High voltage safety

HV Connector Requirements

Low Energy Necessity in Use

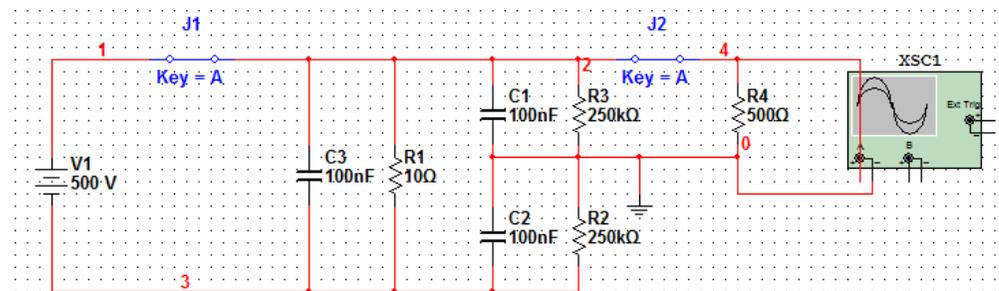
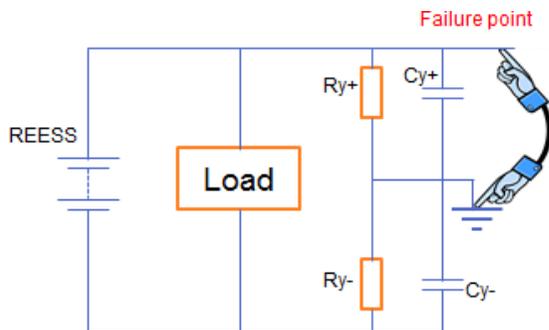
Now low energy requirement is optional choice of post crash in 5.2.2.2.

- ◆ Low energy should be necessary requirement in-use for indirect contact protection as isolation resistance requirement.

- IPXXD/IPXXB requirement when connectors are connected is necessary protection from direct contact on live part;

<OICA response>

- ◆ OICA **understands that there is a theoretical risk of electric shock in case of single failure of electrical insulation**, e.g. damage of solid insulation of high voltage harness, the stored energy of Y-capacitor is high enough and a person touch live part and electrical chassis.
- ◆ However, OICA members **have not experienced such a problem** in the market for more than 20 years since the start of volume production of electrically propelled vehicles.
- ◆ If there are any actual cases in the field, those should be shared among the experts for overall consideration.
- ◆ Robustness of the insulation is the key element of this requirement, but it is difficult to determine the objective assessment method. Paragraph 5.1.1.2.4.2. of GTR 20 includes provisions regarding the robustness of the insulation, but no objective assessment procedure has been developed.

- On the basis of analysis in the next page, Low energy is as important as isolation resistance, so it should be considered in the GTR as isolation resistance requirement.
- Not all the safety requirements are included into the regulations only after there is an accident happened.

The simulation of touching the failure point

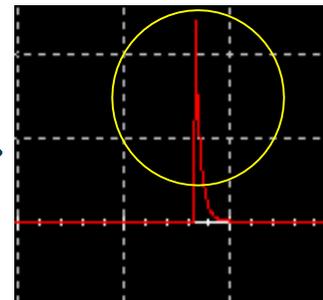
- If the energy is higher than 0.2J above 60VDC /30VAC, it's a danger to the person when there's an one point failure.

Isolation resistance measurement

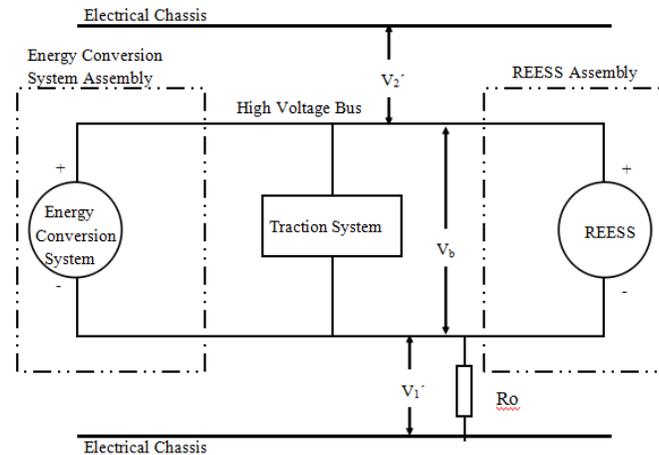
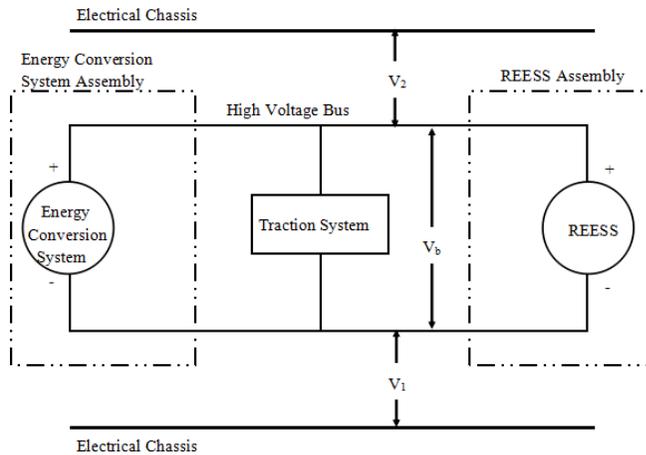
1st: Run the circuit , V_b is higher than nominal voltage;

2nd: measure V_1 ;

3rd: measure V_2 ;

4th: if V_1 is higher than V_2 , add R_0 as picture shows; (suggest $V_0=1M\Omega$)

5th: measure V_1'

6th: measure V_2'

➤ Voltage measured is more stable;

➤ This method minimized the effect of the internal resistance of the voltmeter on the result;

- ◆ What is the problem of existing procedure and why this method is needed?
- ◆ OICA believes that the proposed procedure should be treated as alternative to existing procedure.
- ◆ Technical refinements are necessary since the proposed procedure may not provide valid results in certain conditions, e.g. internal resistance of voltmeters. In addition, we should take account that the possibility of measurement errors will increase with the additional number of measurements.

- China also agree that the existing procedure in GTR now is right.
- China also suggest the new method as an alternative method to existing procedure.
